ENVIRONMENTAL STUDY REPORT
APRIL 11, 2008

WATER AND WASTEWATER PROJECT
LANARK VILLAGE

**TOWNSHIP OF LANARK HIGHLANDS
CLASS ENVIRONMENTAL ASSESSMENT
PROPOSED ENVIRONMENTAL STUDY REPORT ADDENDUM**

MOE COMMENTS ON NWC PROCESS

Figure 3.1 Site location

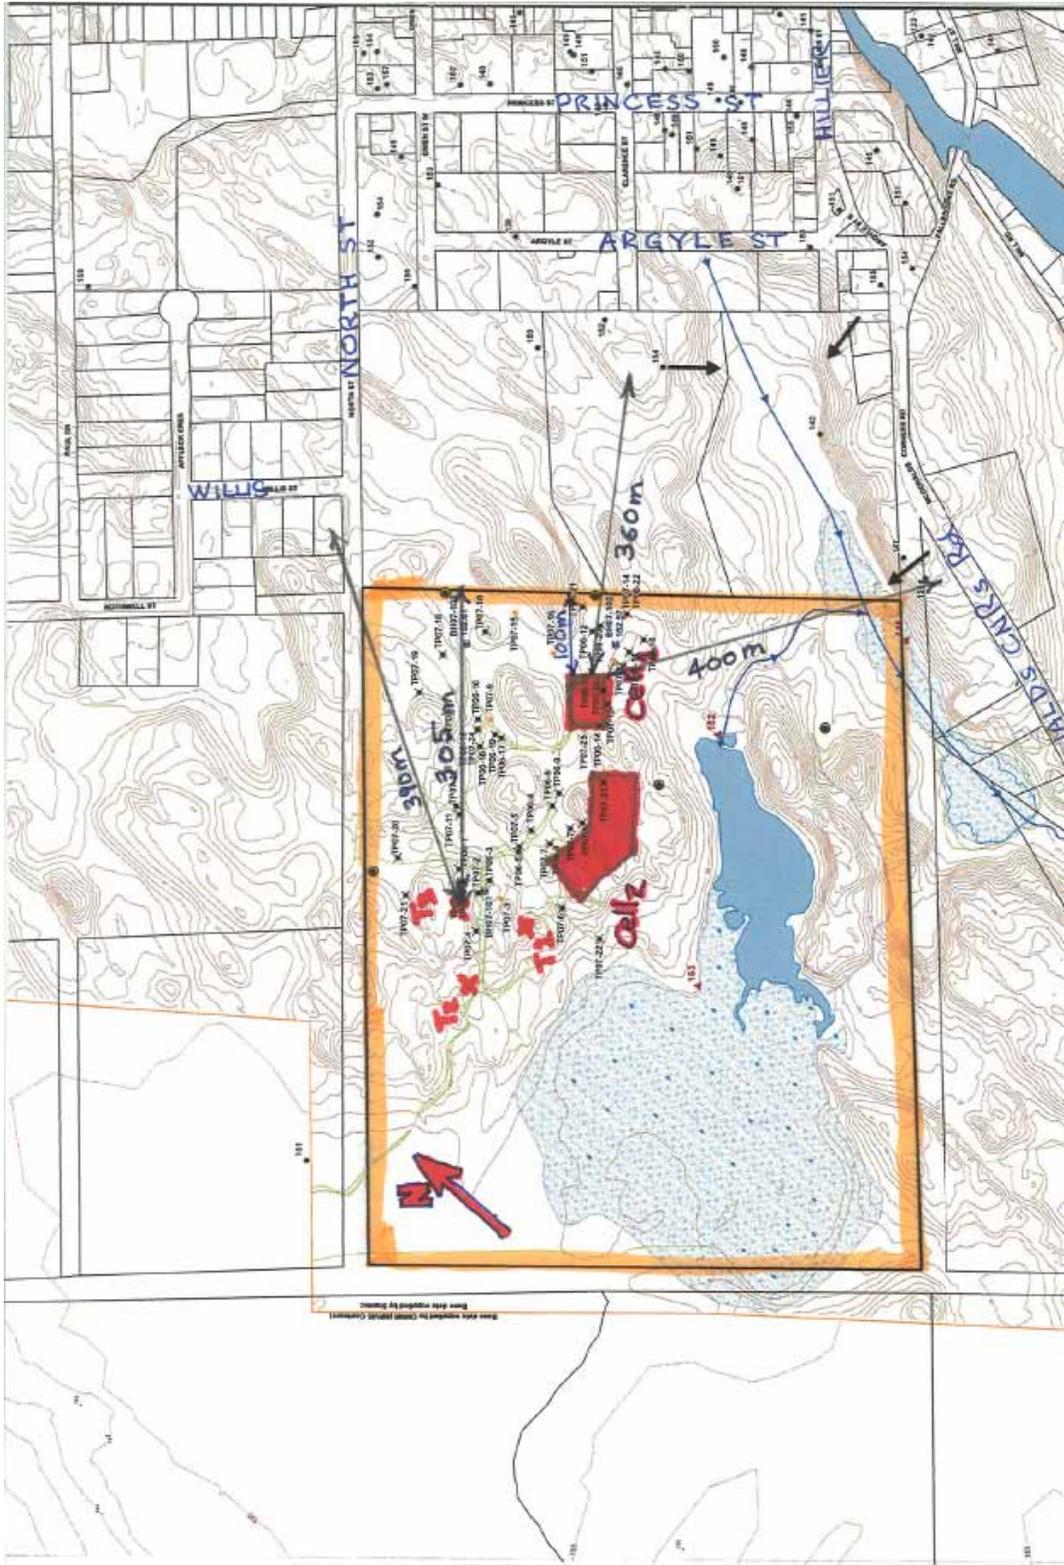
I recommend that the figures in the addendum, particularly figure 3.1, be made larger in the final version of the addendum. It is not possible to read the map or the legend in figure 3.1.

Figure 3.2 Plant Layout on the Site

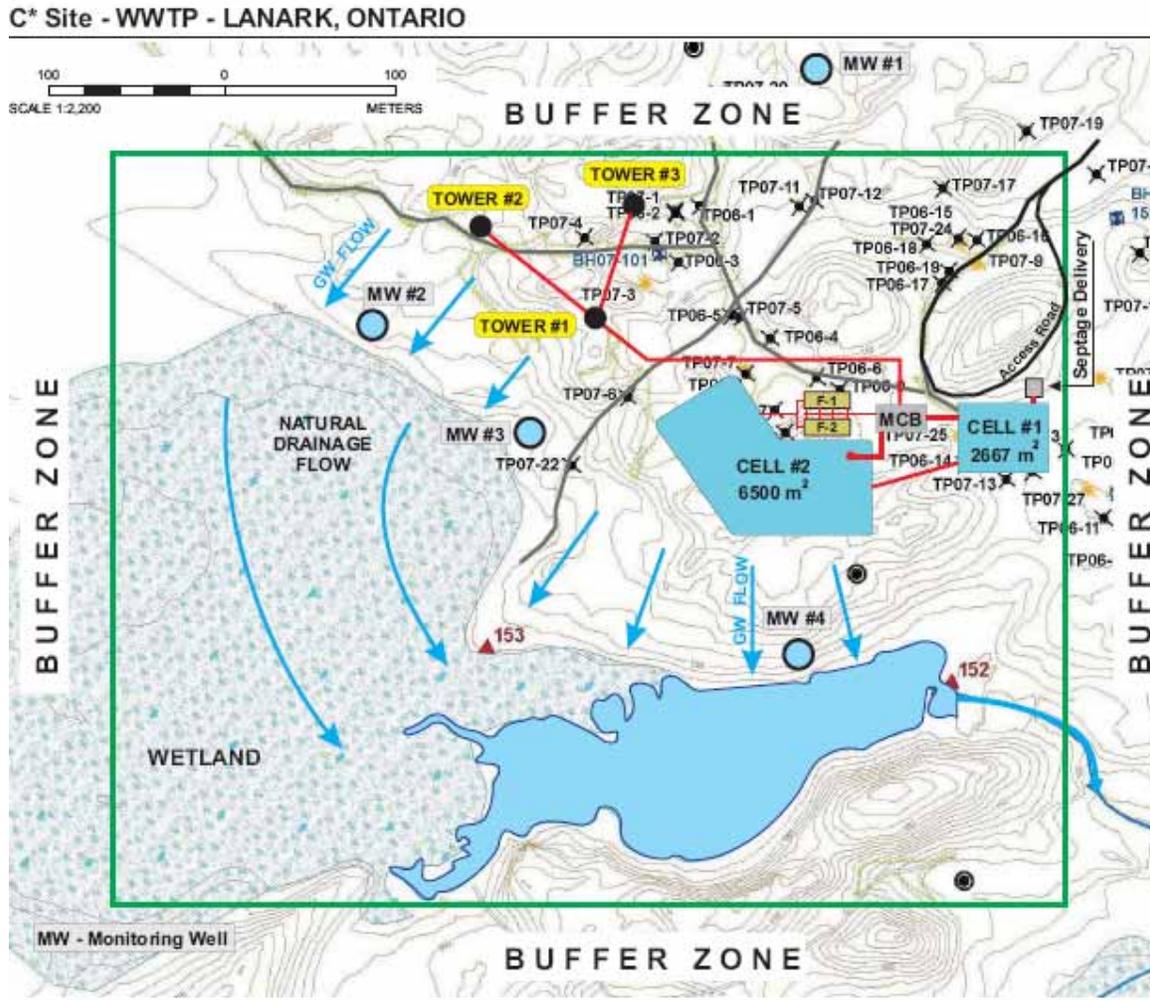
The site plan in figure 2 indicates surface flow routes from the disposal field to the adjacent wetland. Apart from the application rates, it is very important to demonstrate that the topography of the field is such that there will be no runoff from the disposal field.
